ADDENDUM NO. 1

PROJECT NAME: ELLIOTT BUILDING INFRASTRUCTURE UPGRADEUNL
PROJECT NUMBER: J001P049
BID INVITATION NUMBER: 2058-13-7200

CONSULTANT: Alvine and Associates, Inc.
ADDRESS: 1102 Douglas Street, Omaha, NE 68102

DATE OF ISSUANCE: 20 February 2013
DATE OF BID OPENING: 26 February 2013 at 2:30 PM CST

SKETCH
MS-1

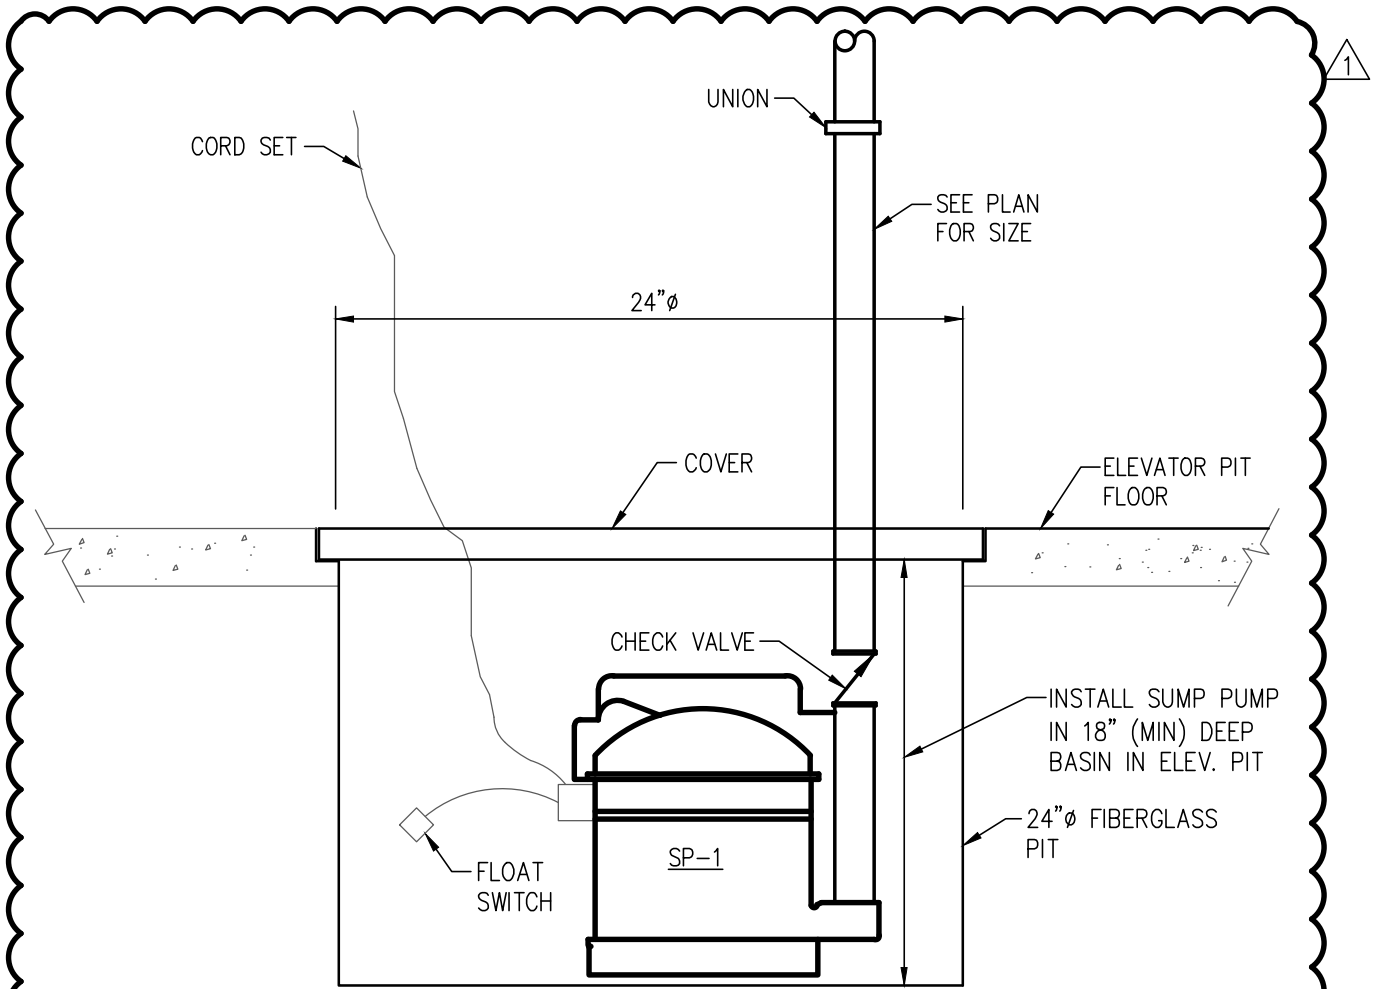
1. Add a sump pump and associated sump pit and plumbing piping for the existing elevator pit. See attached Sketch Sheet MS-1 for location of pump, pit, and discharge piping.

SKETCH
MS-4

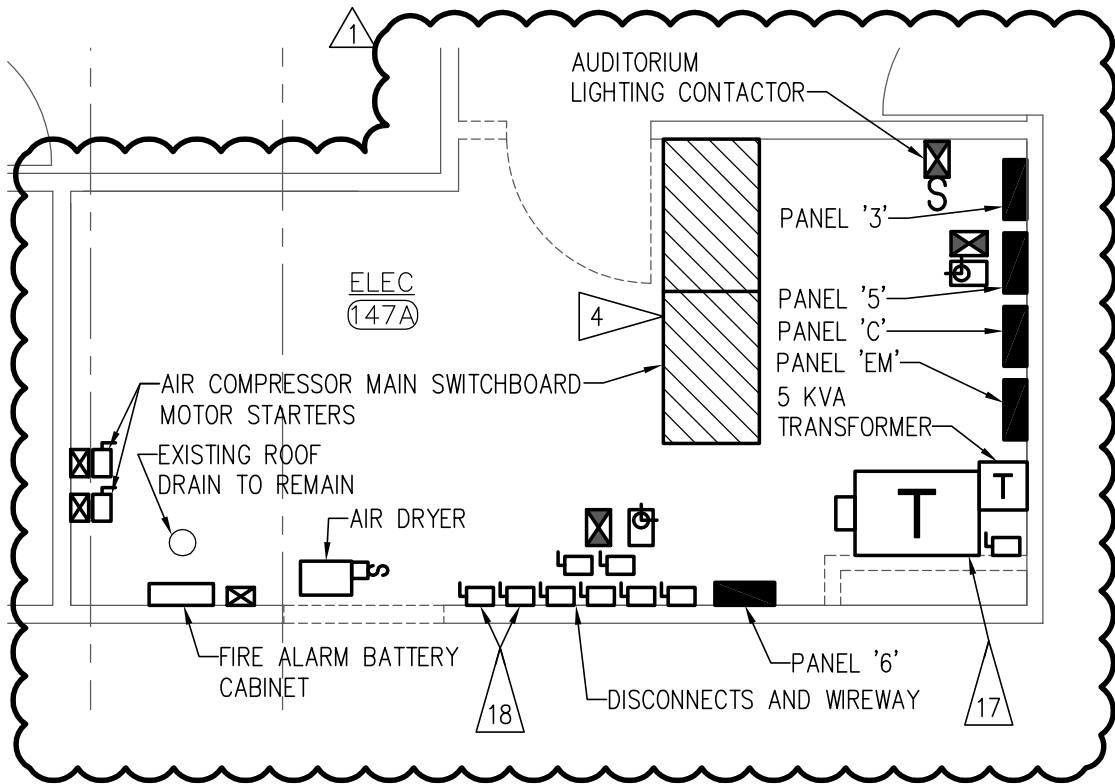
2. Modify fan type on Air Handling Unit Schedule to be a Direct Drive Plenum style. See attached Sketch Sheet MS-4 for revised schedule.

SKETCH
ES-1

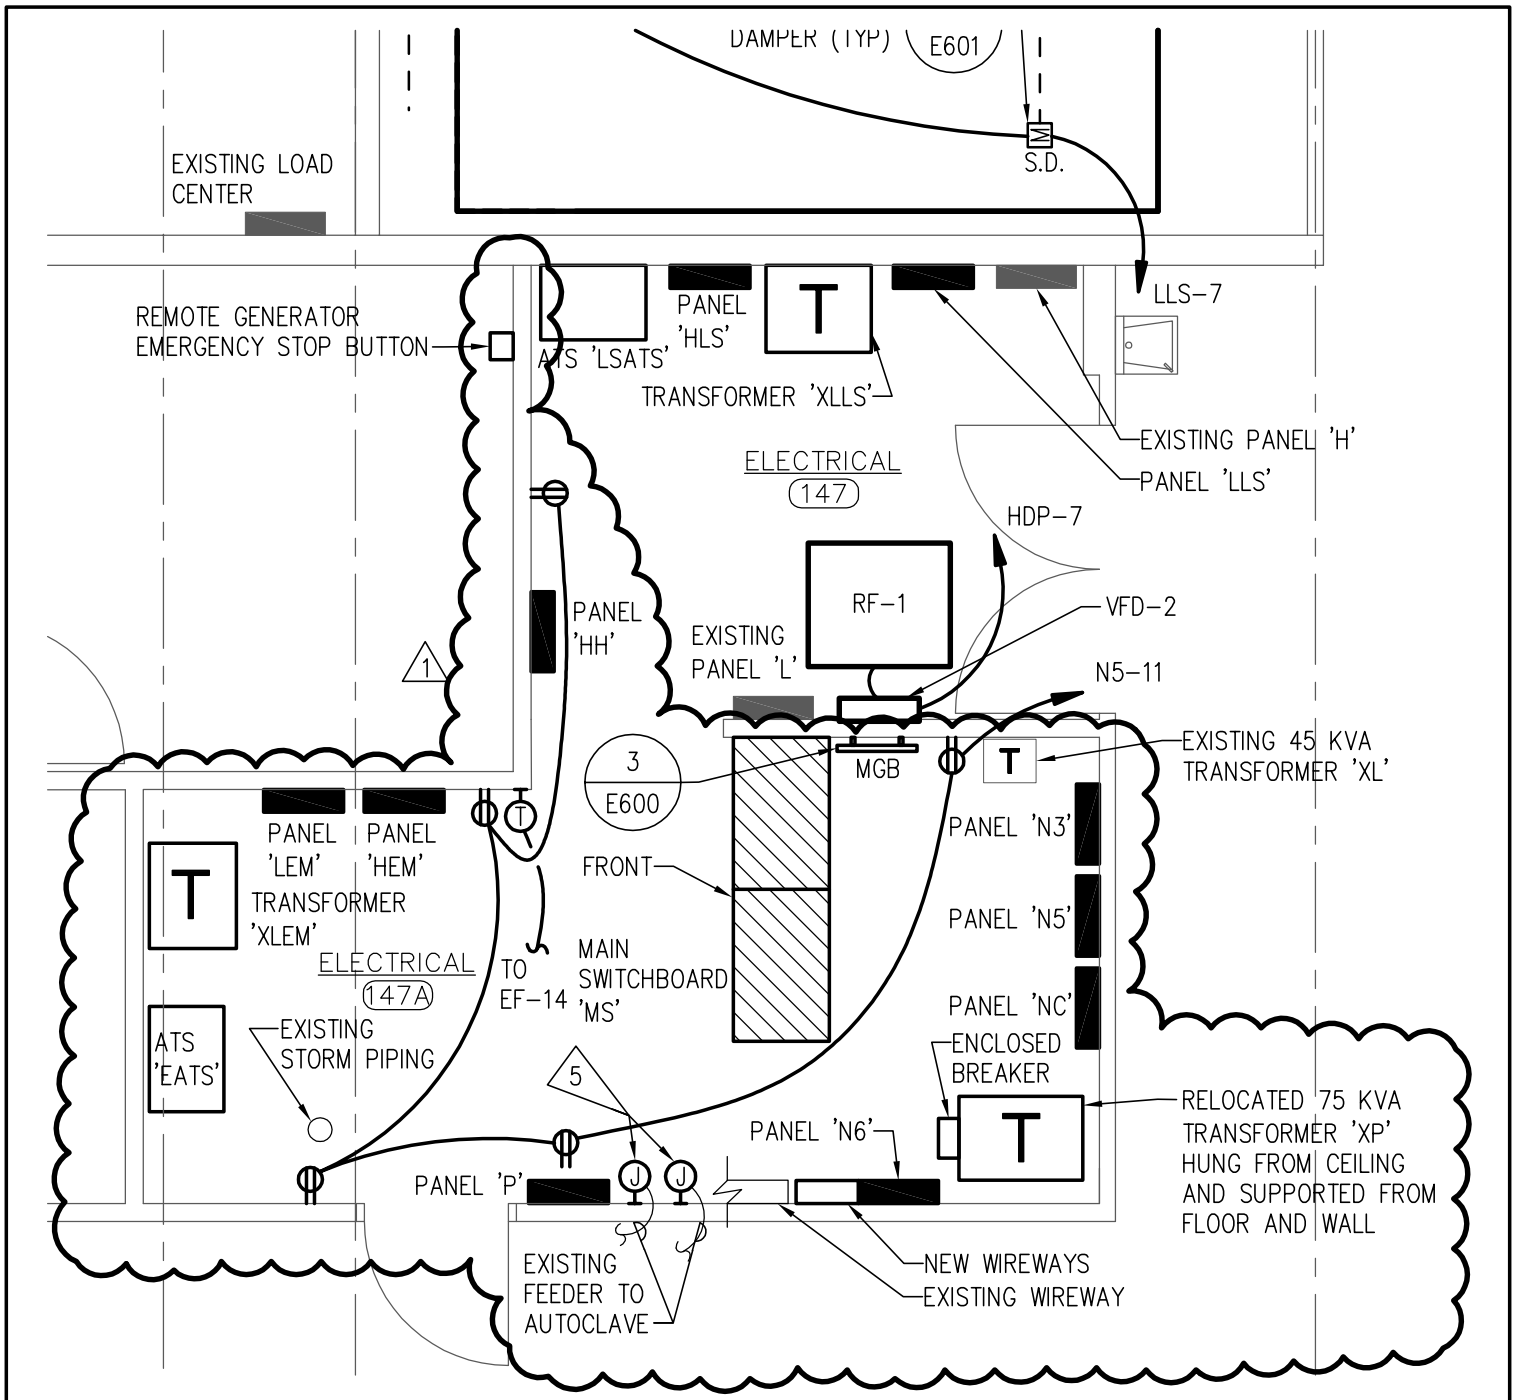
1. See Sketch Sheet ES-1 for modified 147A Enlarged Plan1/E011.

- 17 RELOCATE EXISTING 75KVA TRANSFORMER 'TP'. REMOVE SUPPORT METAL AND WIRING.
- 18 REMOVE 60AMP AUTOCLAVE DISCONNECT AND WIRING FROM DISCONNECT TO SOURCE. WIRING FROM DISCONNECT TO LOAD TO REMAIN.
